LAND TECHNOLOGIES, INC.

Response to Comments

Project Name: 927 Townhomes
Project File Number: PA24-007 - Technical Review 1
Review Completion: April 29, 2024

Recent Photos of integrated Bio-cells from 2007 project

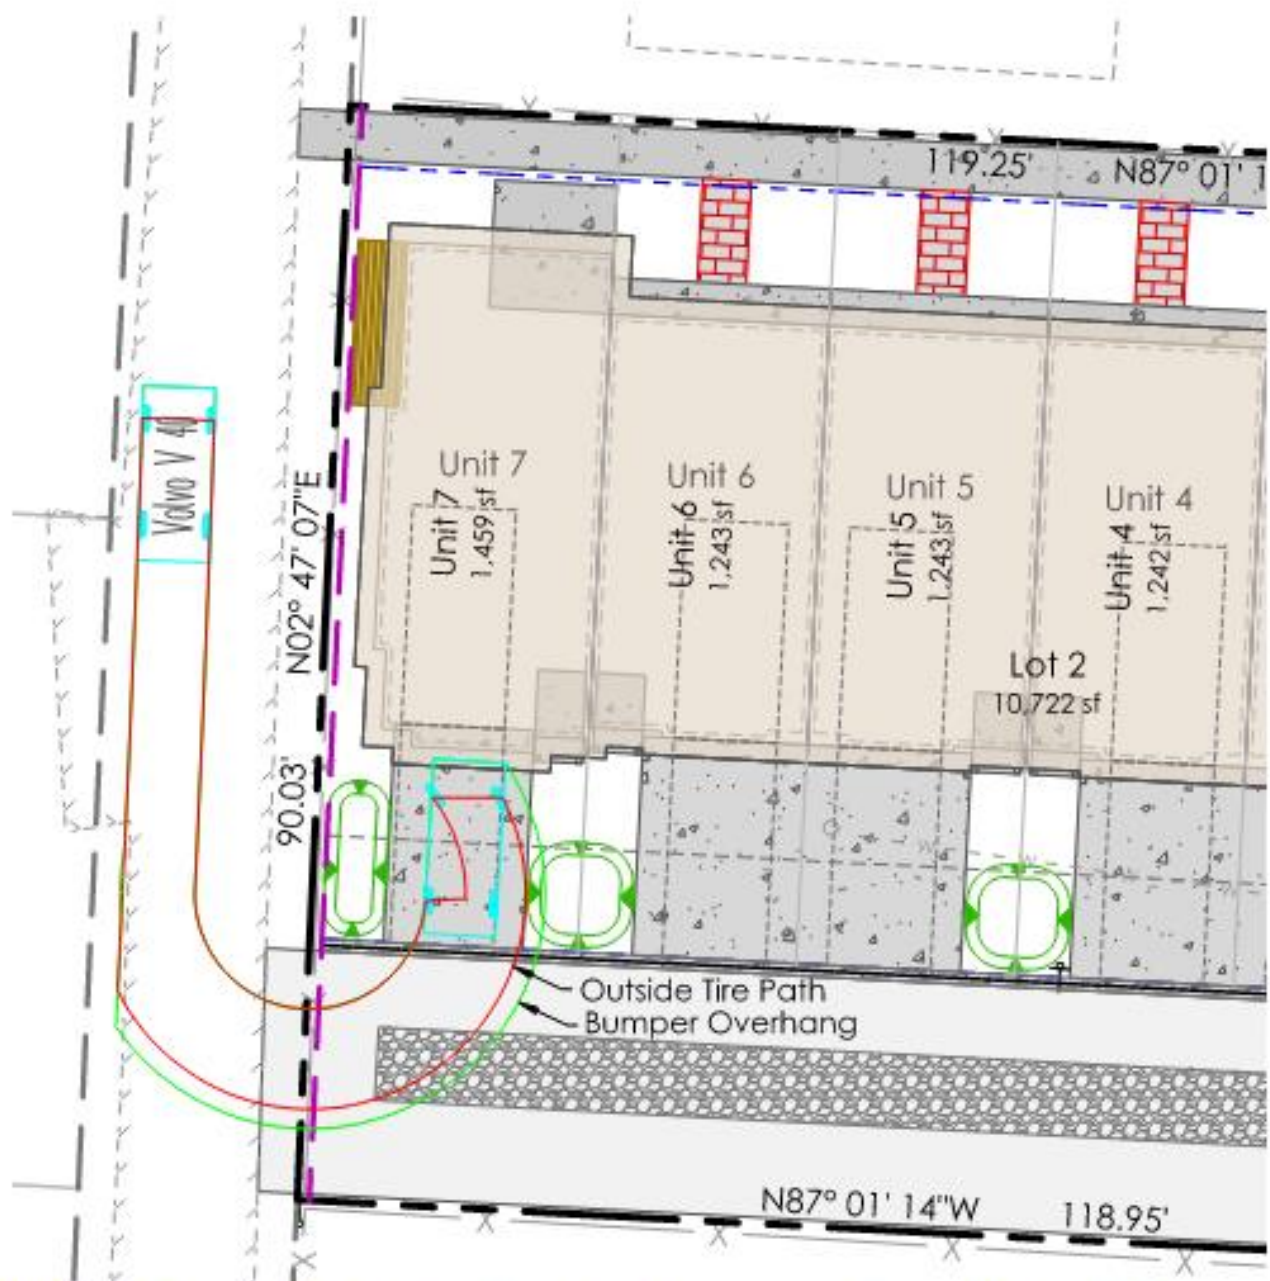
6. I'm unsure if the proposed biocells in back of the units are the best way to mitigate runoff. Based on the size of the proposed cells it may be best to simply utilize an infiltration system.	Under MR5 – We are required to implement BMPs consistent with the first feasible BMP. Bioretention is that BMP and the preferred stormwater runoff BMP for PGIS. We have designed and developed many small systems like this that are functional and serve to beautify the typically barren drive aisles. We have done these types of cells in projects as long ago as 2007. Photos of those examples are added to the end of this sheet.
